Project # 5015097

RFI #: 0220.2

SHCE - DP#2 - MRI Opening Infill Confirmation

Reference A10.47 and HPSK-0220.2:

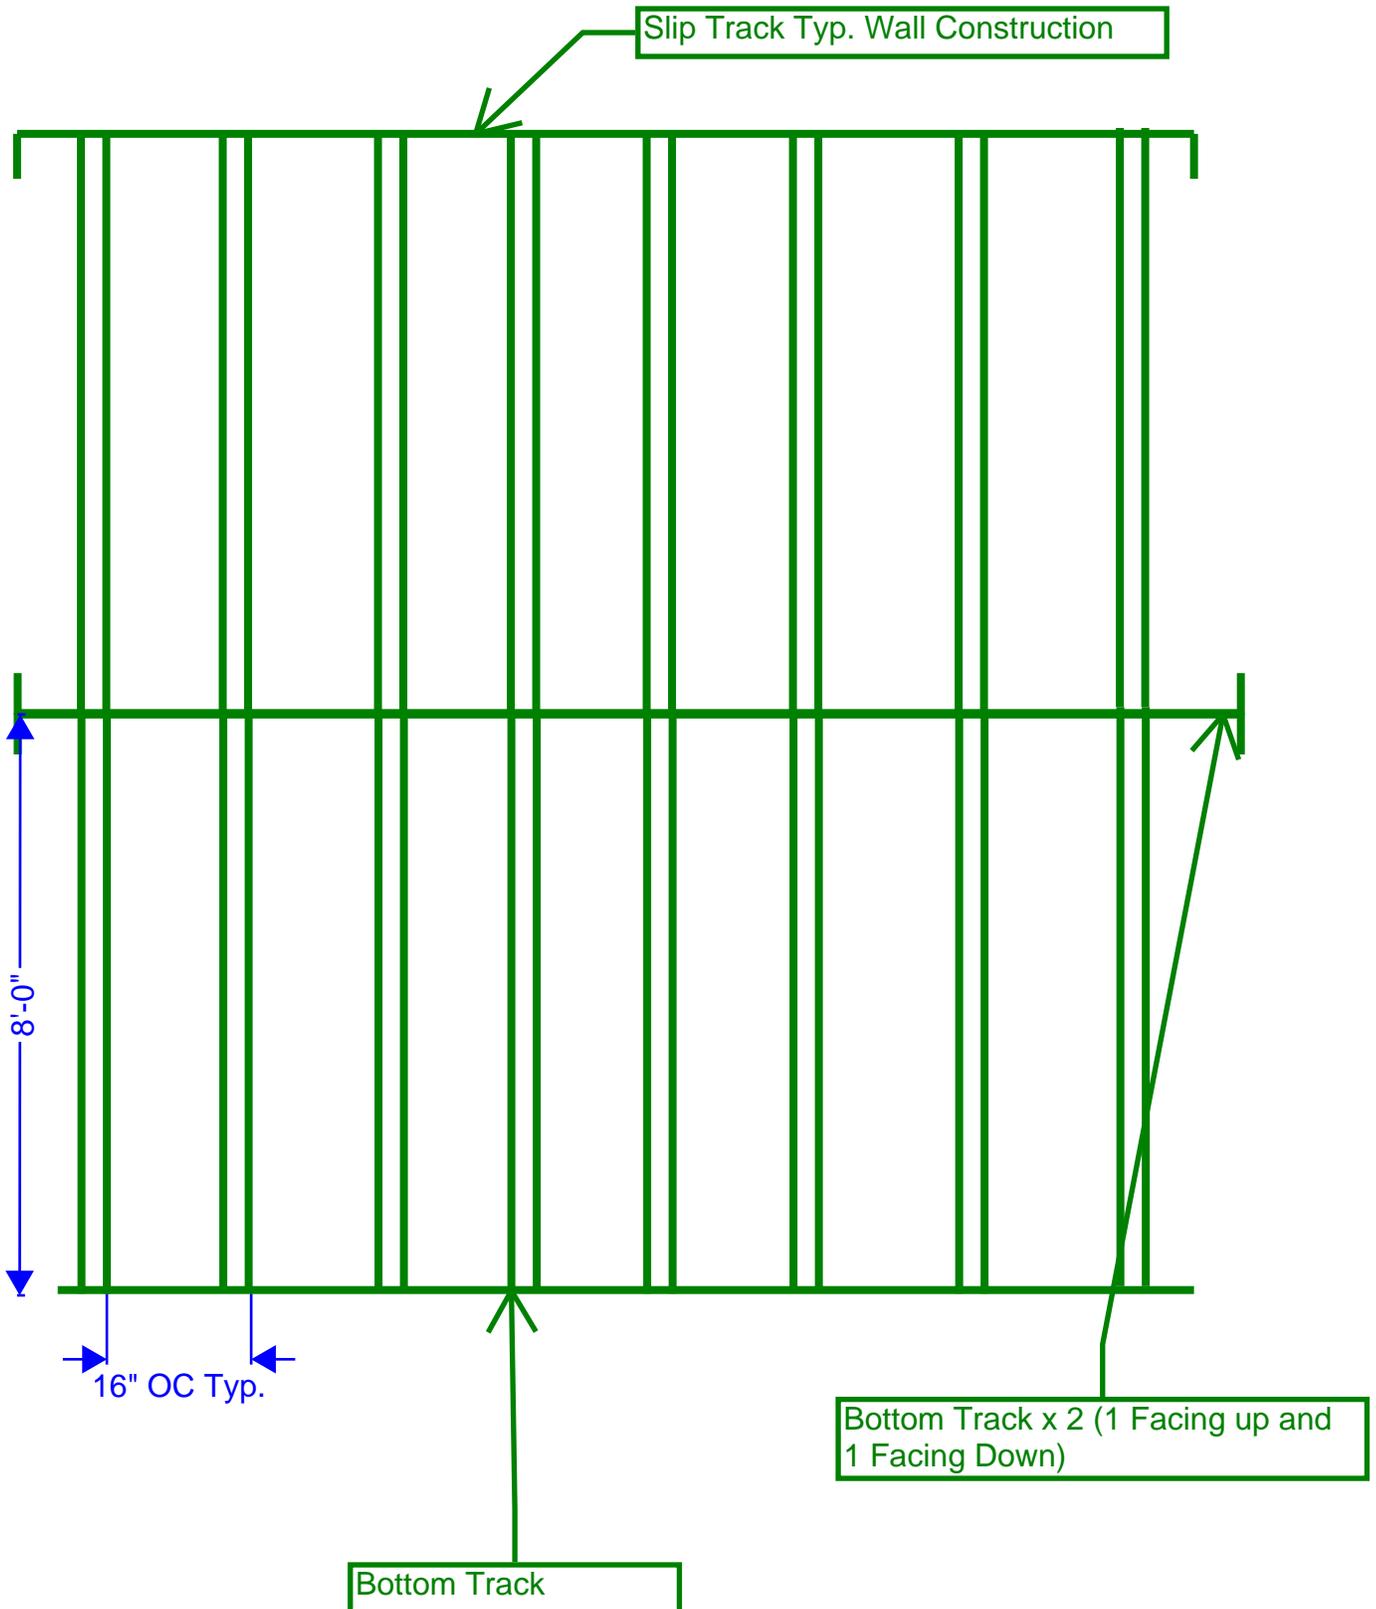
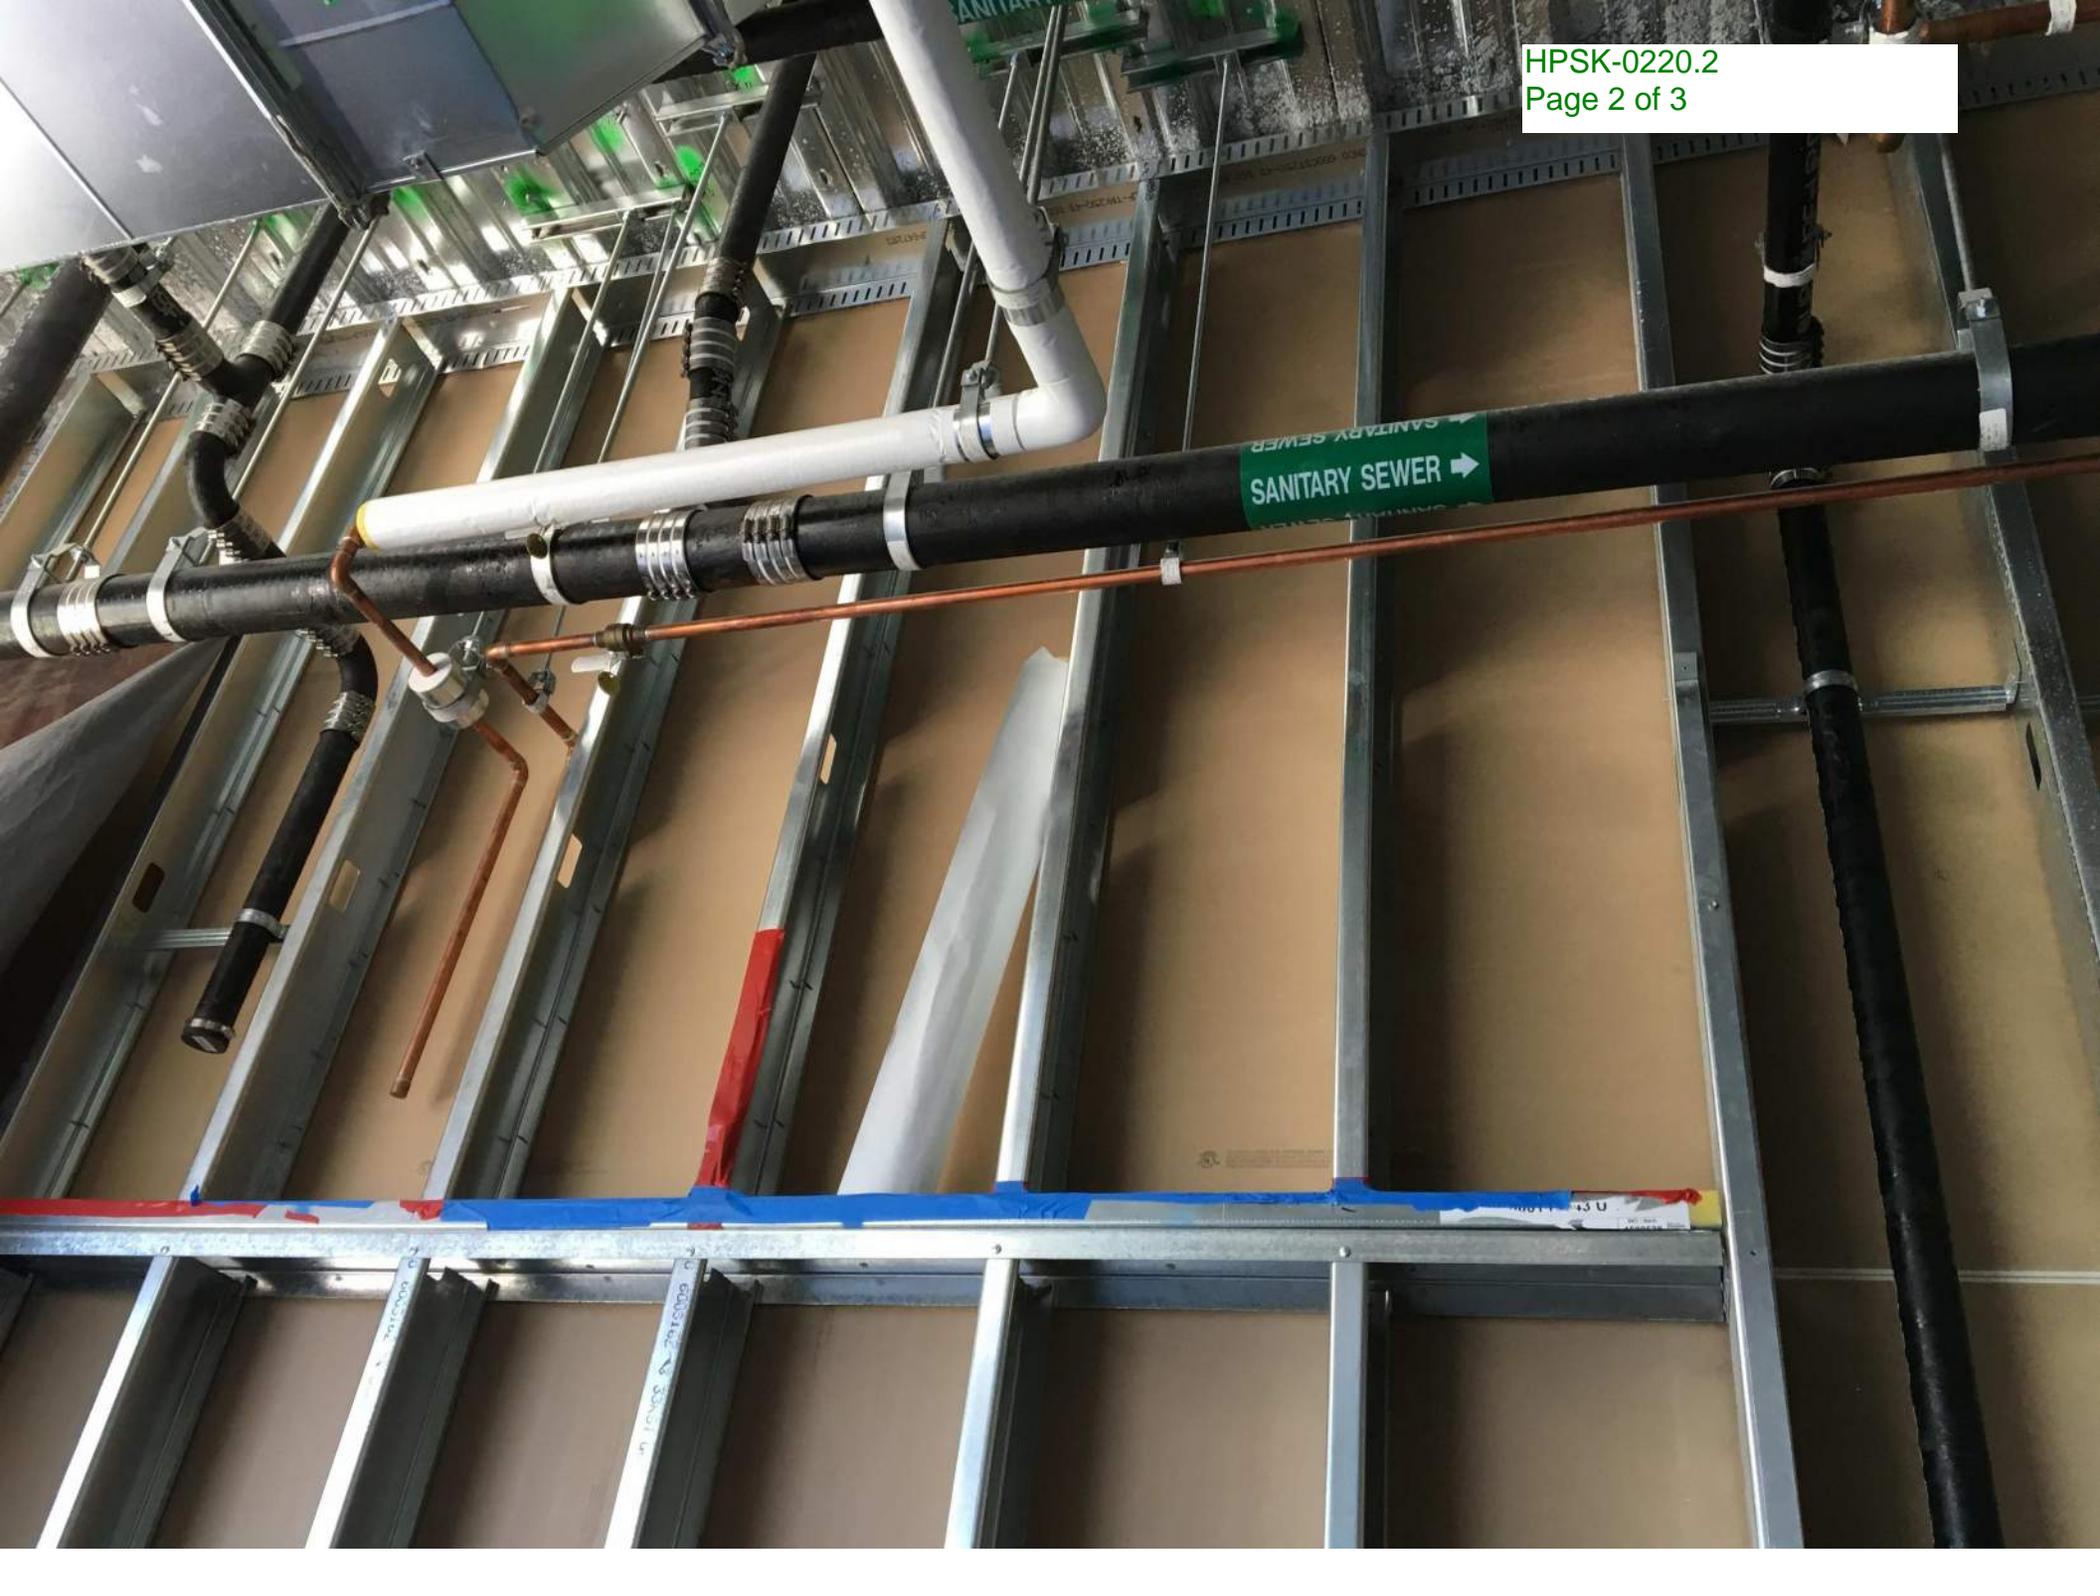
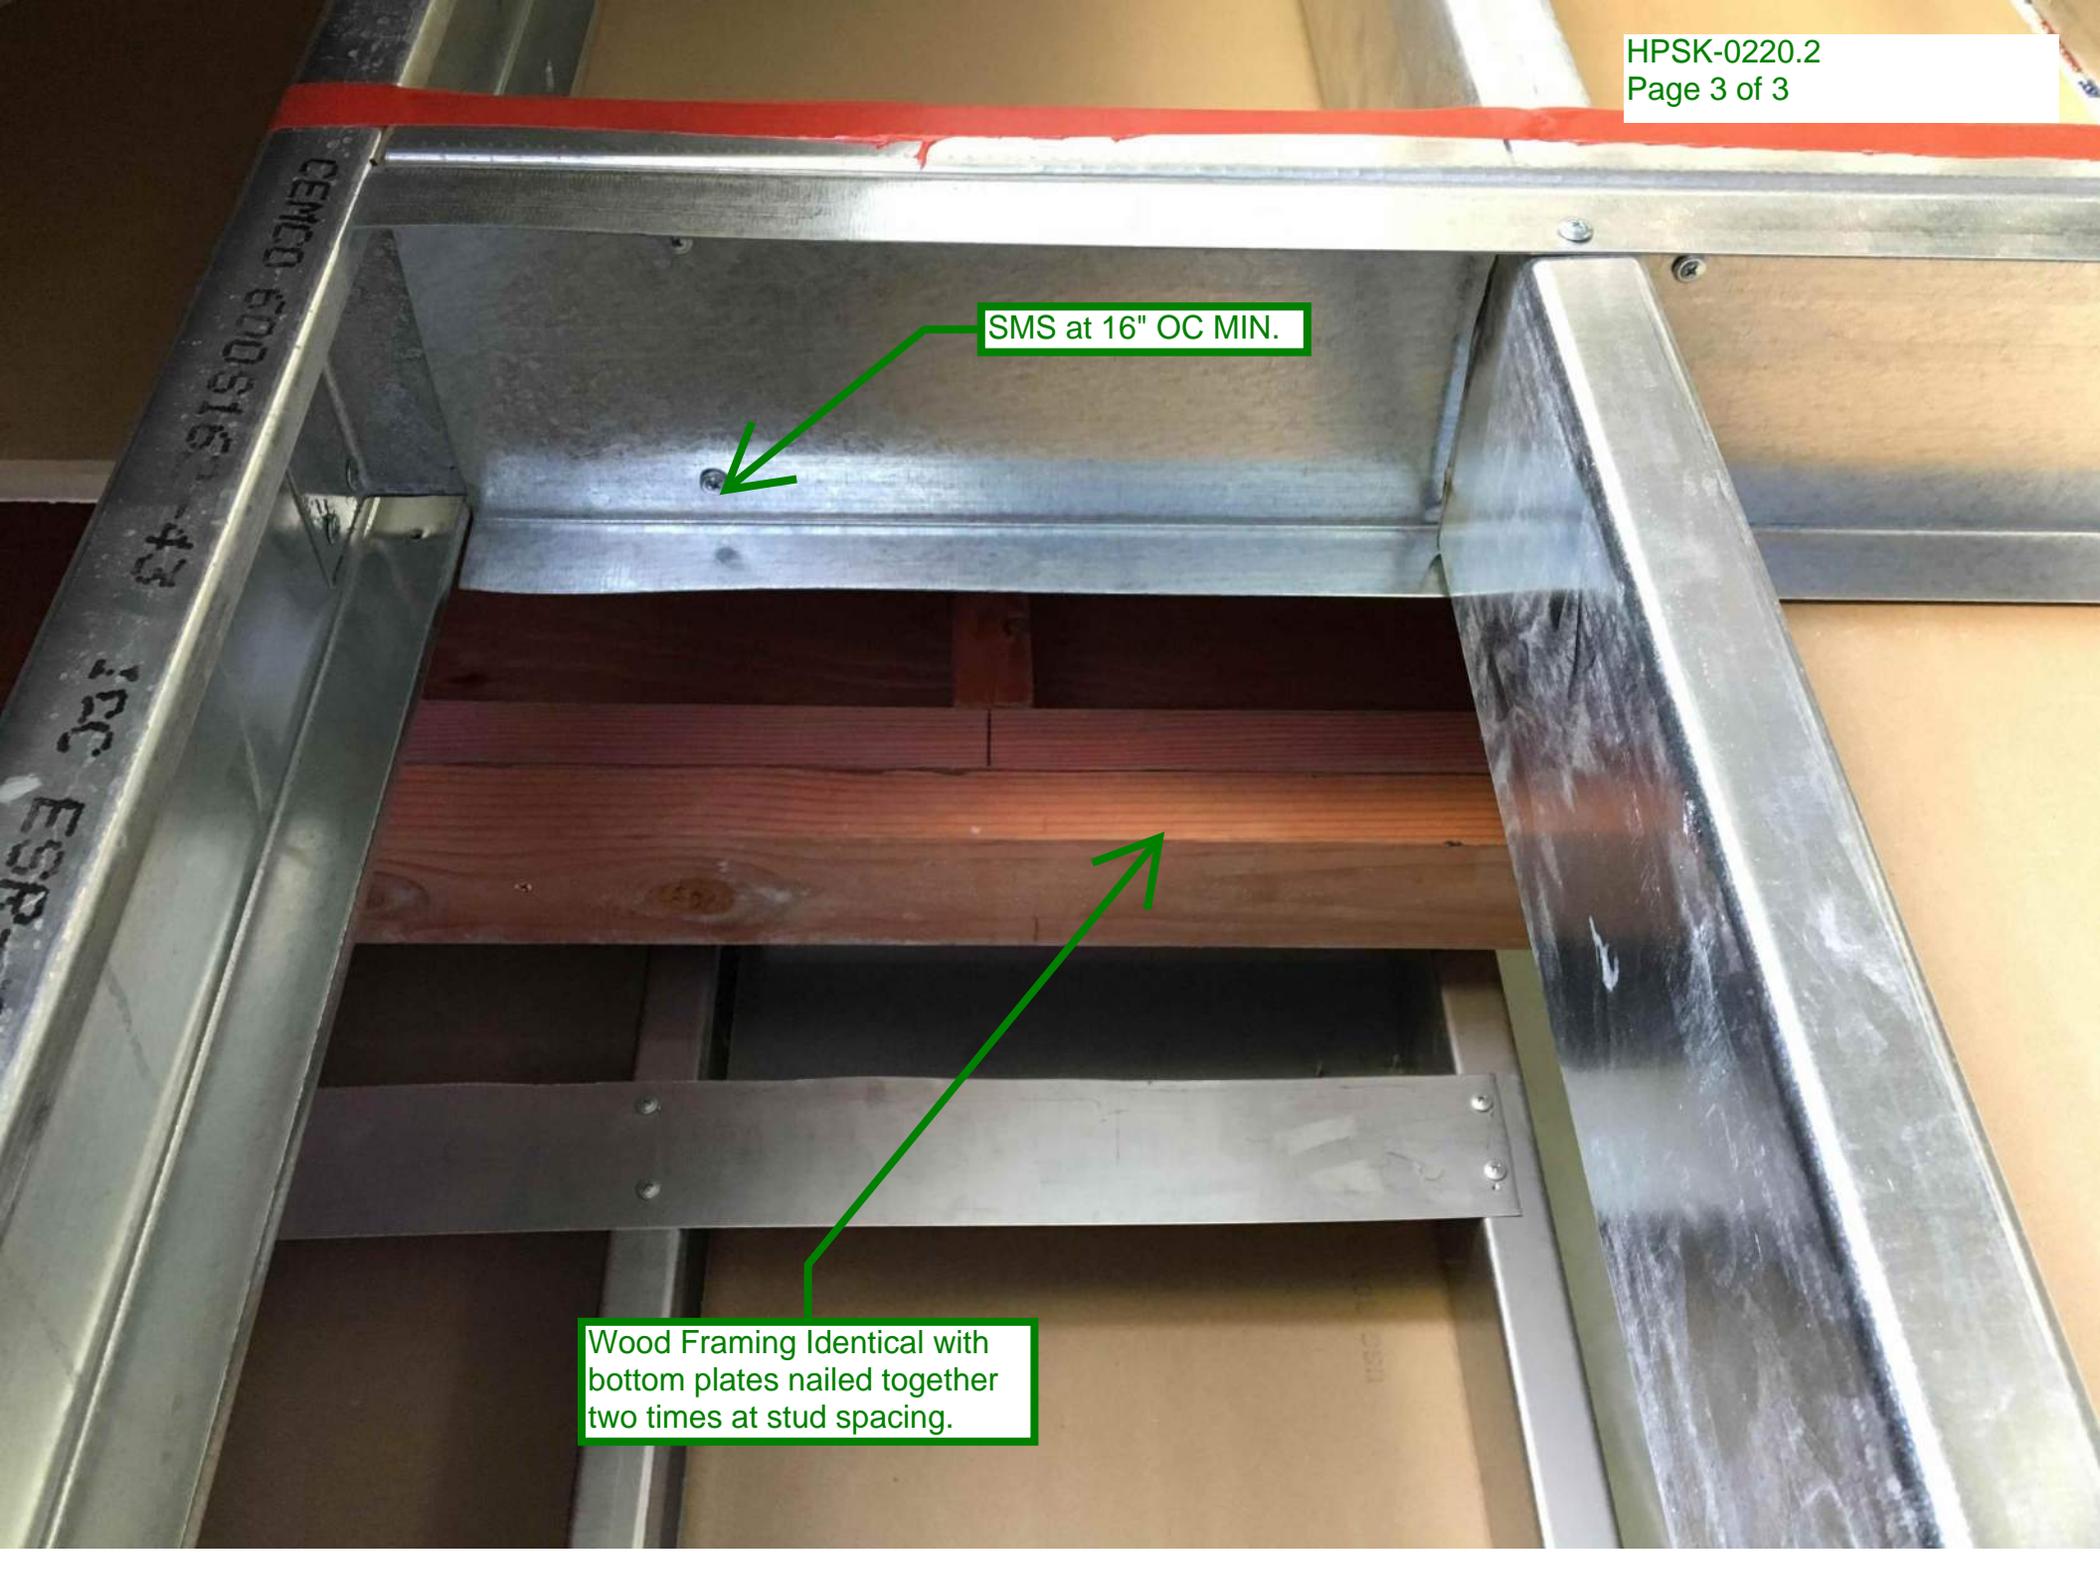
The wall opening for the magnet delivery was temporary framed as a cased opening to allow the magnet to roll in. To infill this area, a bottom track was flipped and infilled with studs at the typical 16" OC. This track was secured with 2xSMS at 16" OC.

The wood framed wall for shielding was framed identical with wood materials.

Please confirm infilling these openings is acceptable as shown in HPSK-0220.2.

KMD-Structure take no exception to infilling the openings for the MRI Magnet delivery as shown in HPSK-0220.2.
R. Sheng - KMD
2016-06-22

SMS at 16" OC MIN.

Wood Framing Identical with bottom plates nailed together two times at stud spacing.
